Coeur d'Alene Lake Tributaries Temperature Total Maximum Daily Loads

**Addendum to the Coeur d'Alene Lake Subbasin Assessment
and Total Maximum Daily Loads**

**State of Idaho
Department of Environmental Quality
January 2012
Revised February 2012**

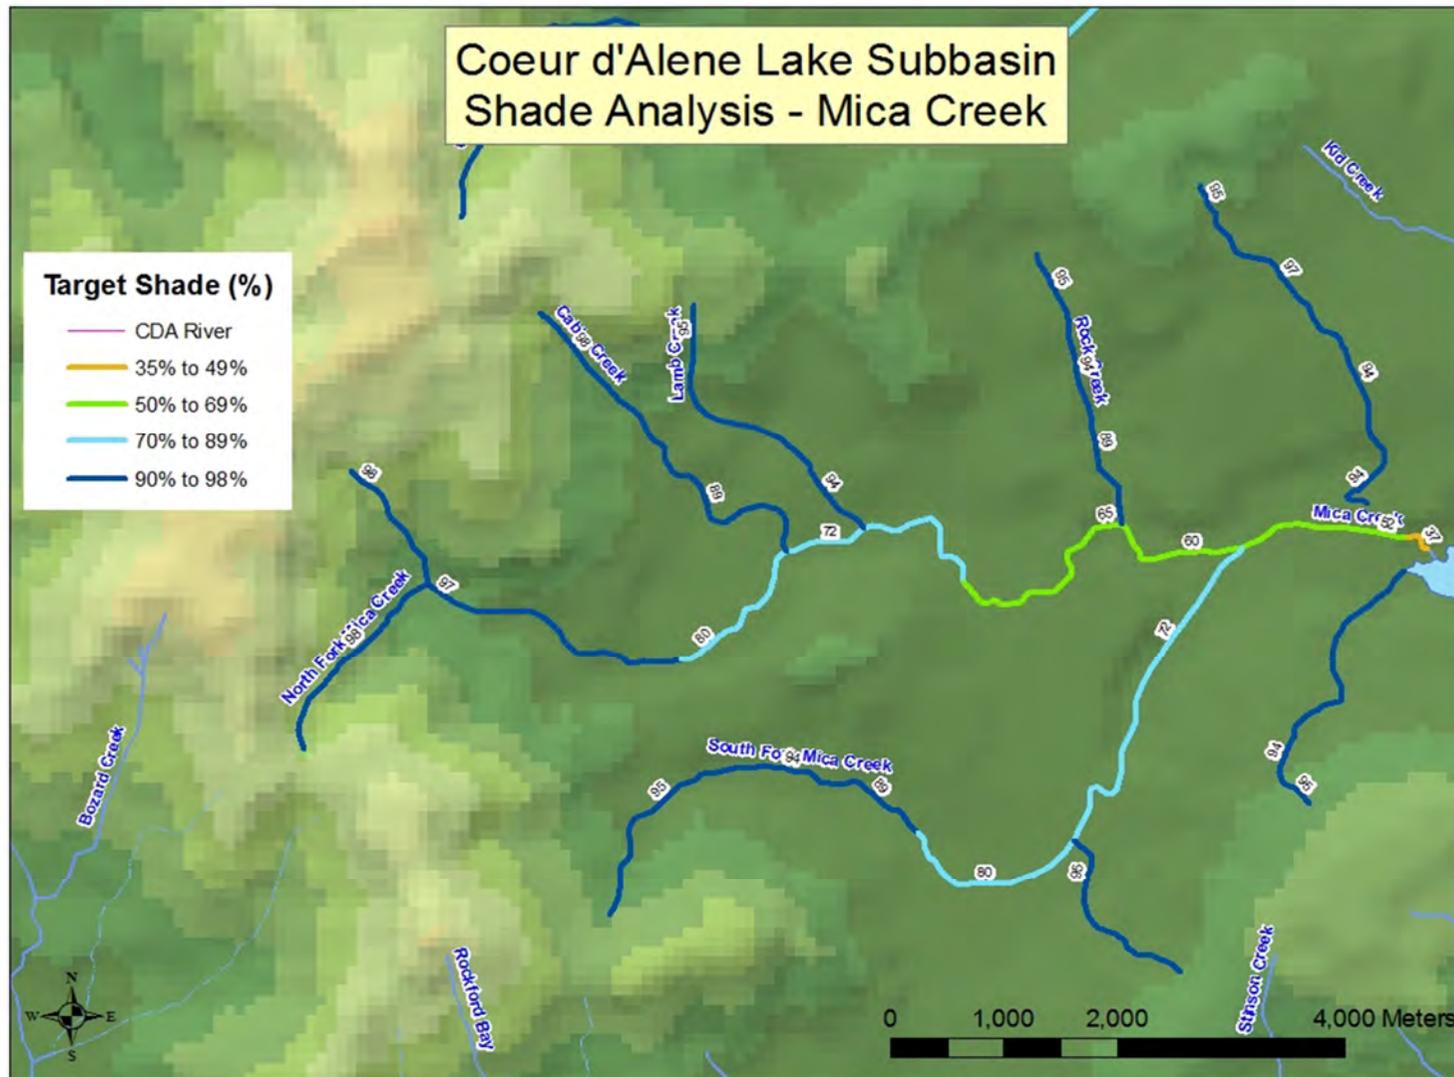
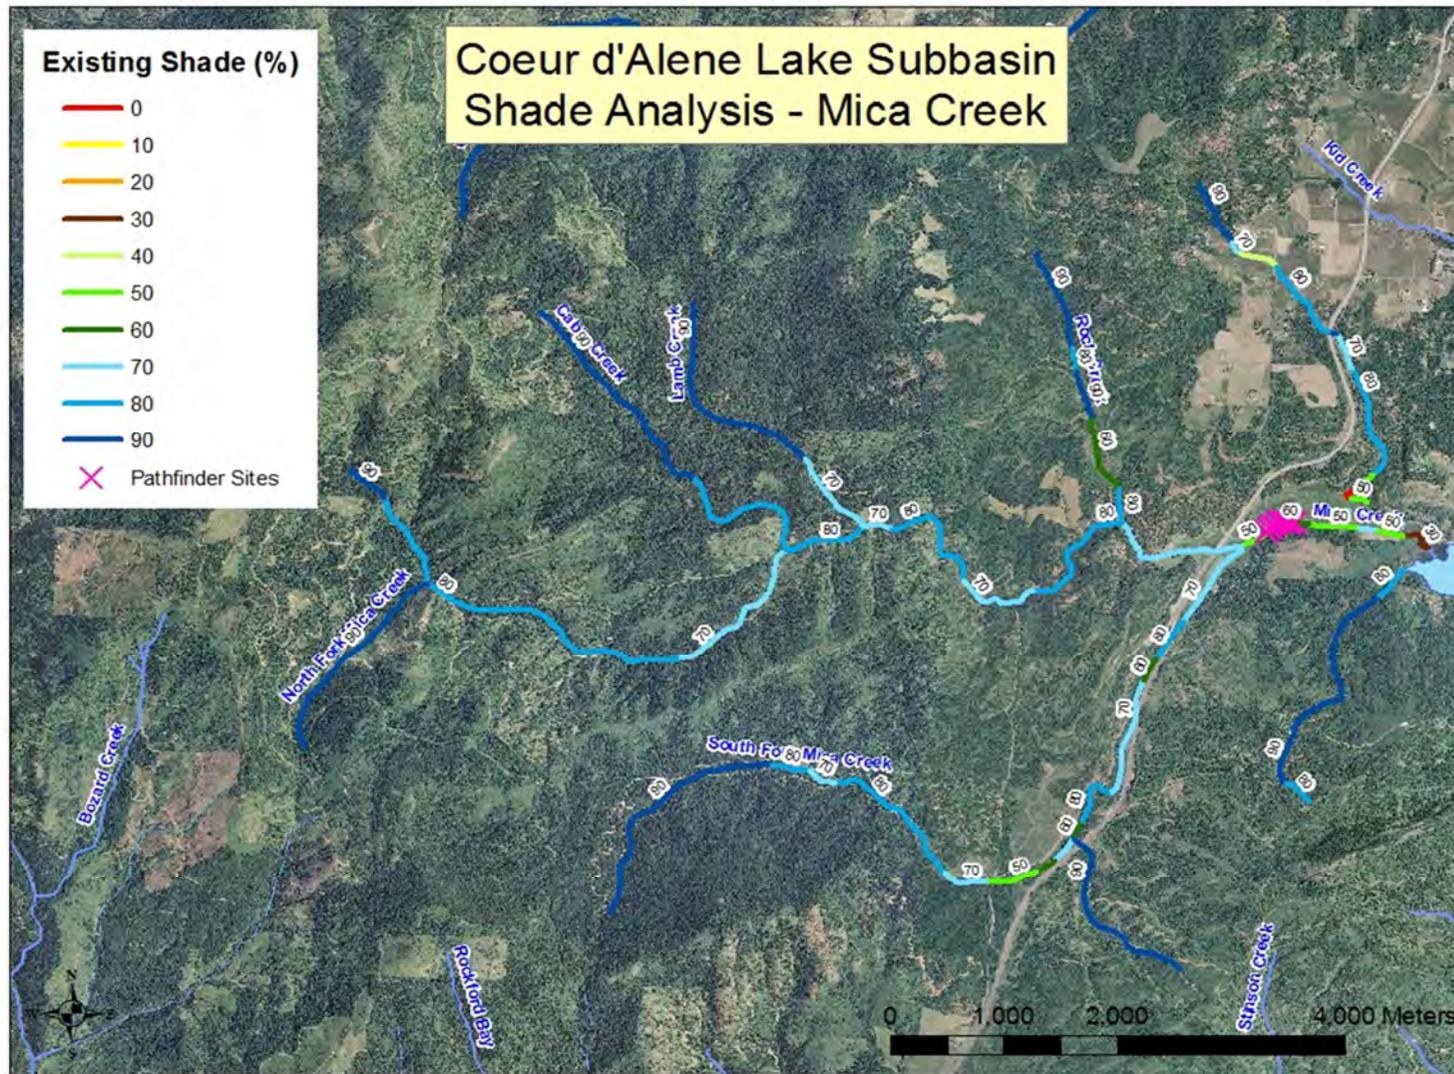
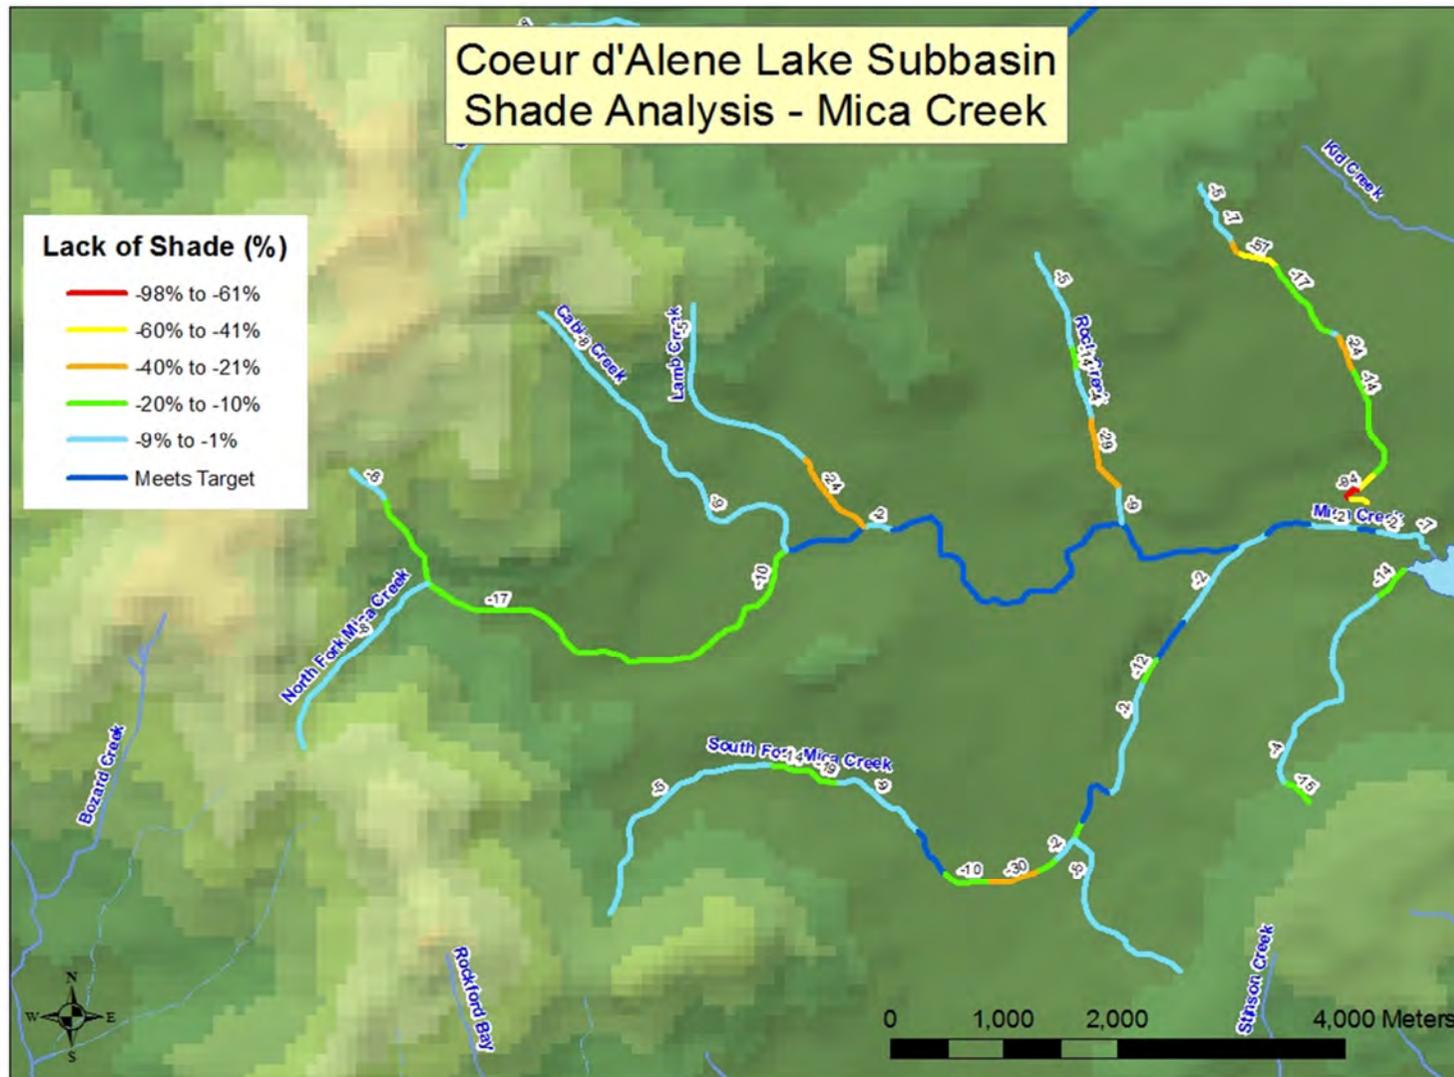
Comment 1:

In response to your comment, DEQ conducted solar pathfinder along the reaches on Mica Creek of concern. Indeed, the amount of shade on those reaches was much more than that originally described in the TMDL document. Maps and text in the TMDL have been adjusted accordingly.
